Representations: Outcomes

Document Reference: D002

This document sets out our response to issues relating to outcomes in the Draft Determination

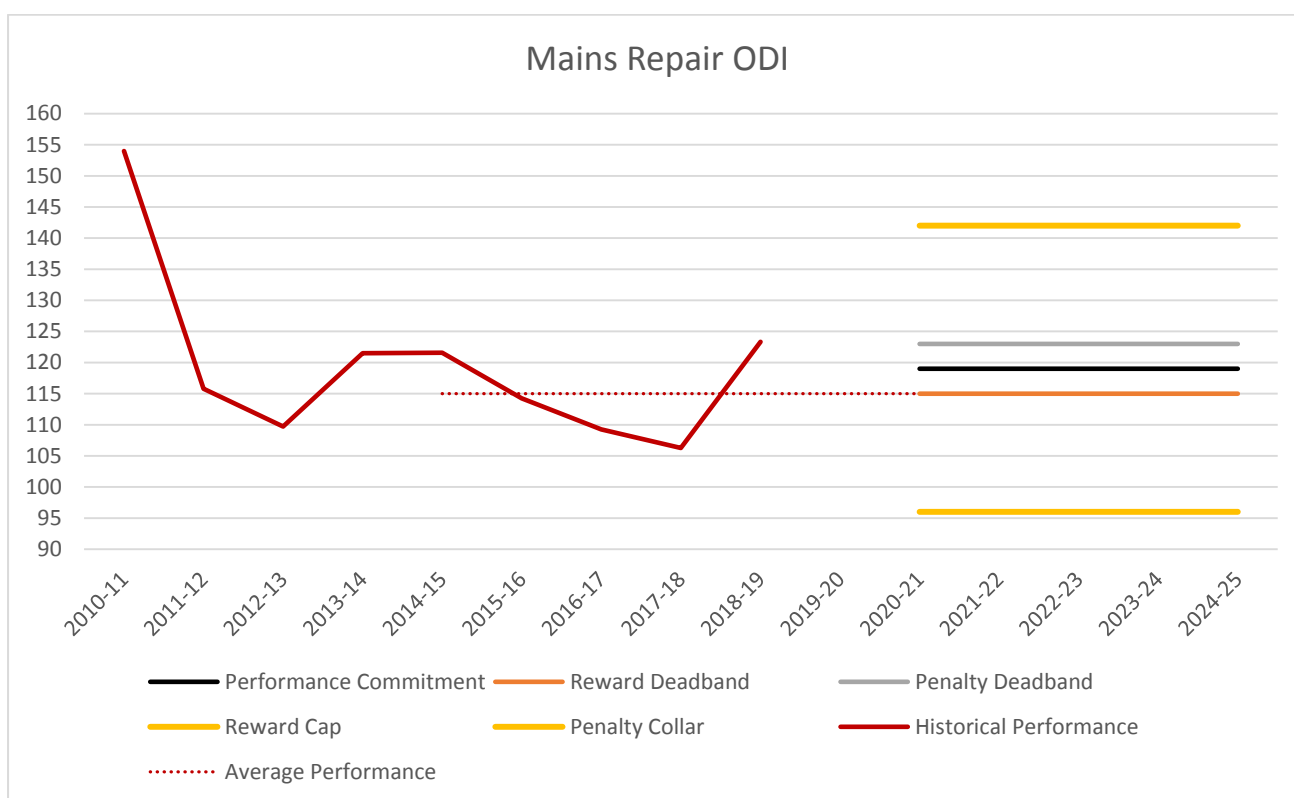
The graph below shows our target, compared with past performance, and the proposed deadbands, cap and collar.

- Sets the mains repair performance commitment level at 119 repairs per 1,000 km.
- Adjusts the ODI outperformance rate.
- Introduces a deadband and a collar on penalties.

Figure 1 Systems thinking capability maturity performance commitment

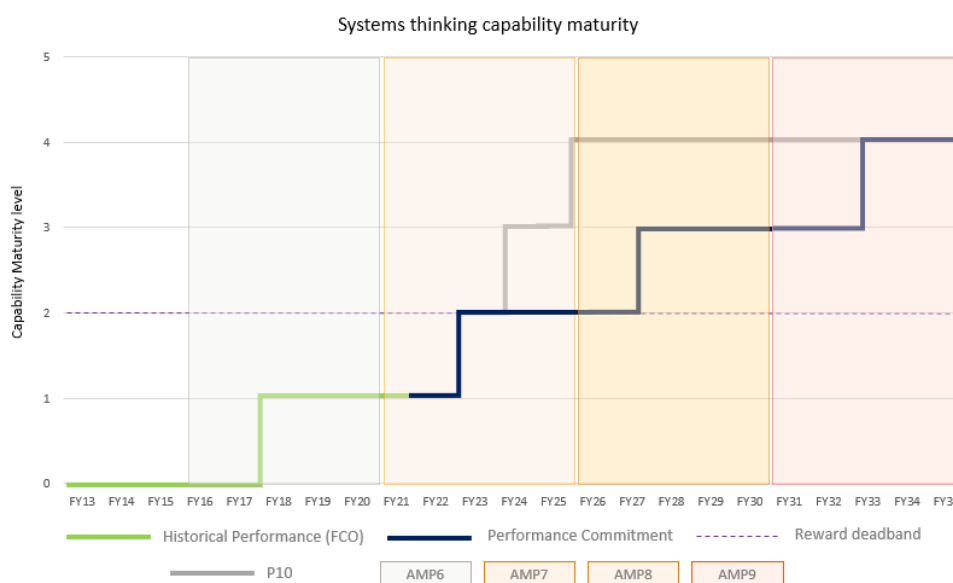
However, in order to demonstrate our sincere commitment to the delivery of this capability uplift, and to further incentivise delivery of the innovations required to achieve the already more stretching target early in AMP7 (year 2), we are prepared to remove this penalty deadband.

Also, exceeding our target in any year would result in an annual reward, although if this capability maturity is not retained for the remainder of the AMP7 period the reward would be returned to customers in the year that the performance level deteriorated back to target. Similarly any delay in meeting our planned target level of 2, or any subsequent reduction from this level, would result in an annual penalty. However this penalty would be recovered if the target level was achieved in a subsequent year and this performance level was maintained for the remainder of the AMP7 period. Figure 1 below illustrates the proposed performance commitment.

Figure 2 Systems thinking capability maturity 'stretching changes'

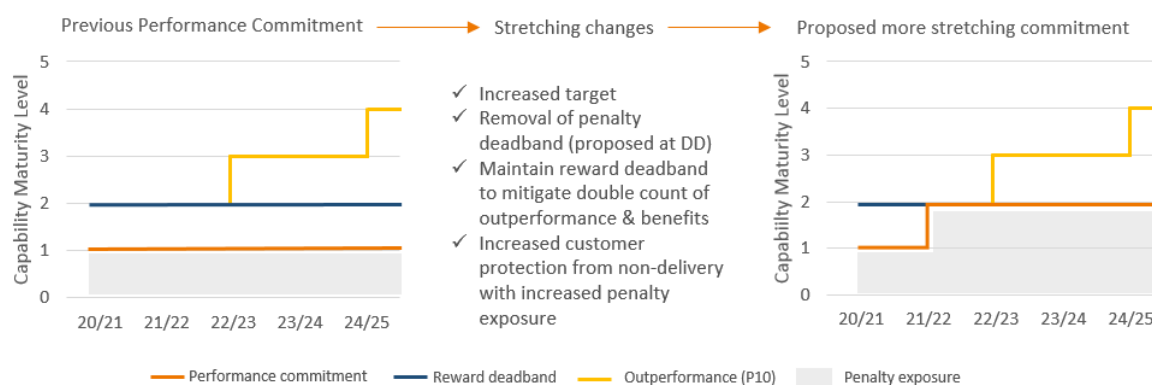
This change to a more stretching penalty and reward regime:

- Provides a clear commitment to improve within the 2020-2025 period and beyond
- Maintains the incentive to innovate, accelerate the transformation and secure the extensive benefits and resilience for customers in the long term, yet earlier than would otherwise be possible within the in-period economic regime
- Offers the maximum protection to customers from non-delivery or regression.

Figure 2 below illustrates the changes to a more stretching commitment.

Figure 1 UU historic performance for the mains repairs PC

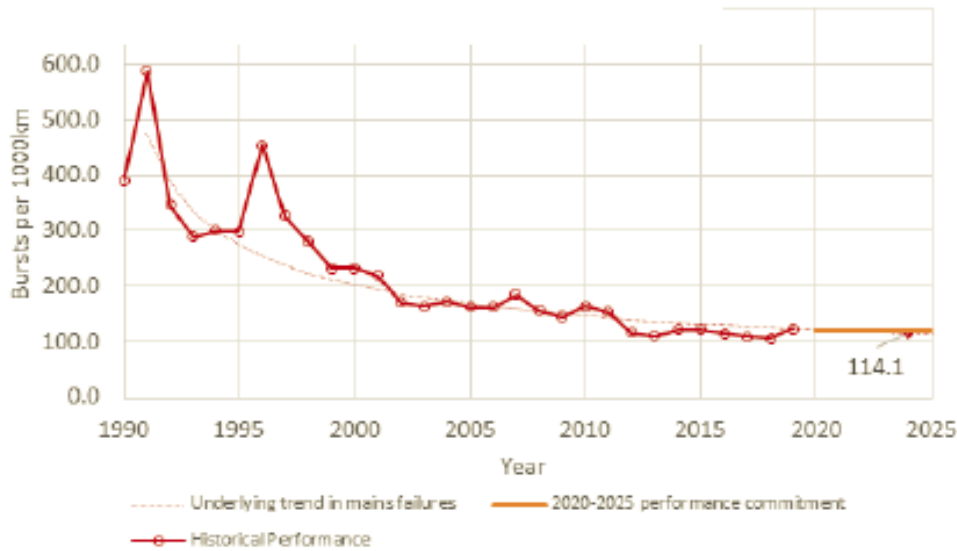
The Company had a choice of baseline performance from which to apply the additional mains repairs;

- a) Use the long-term underlying trend line, based on actual performance from 1990-2019

Figure 4 – 'box and whisker' graph of proposed 2025 targets for the mains repair PC

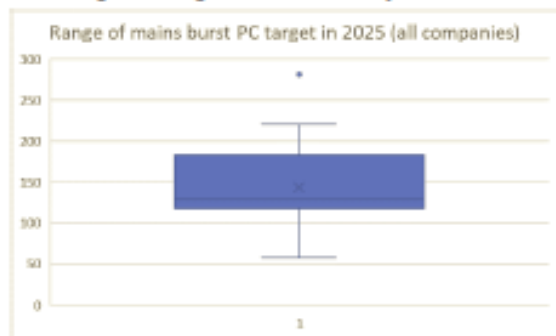
Analysing the range of mains burst PC target for 2025 from all publicly available business plan submissions, correcting UU's target to 119/1000km/yr, shows that 119 is still upper quartile performance.
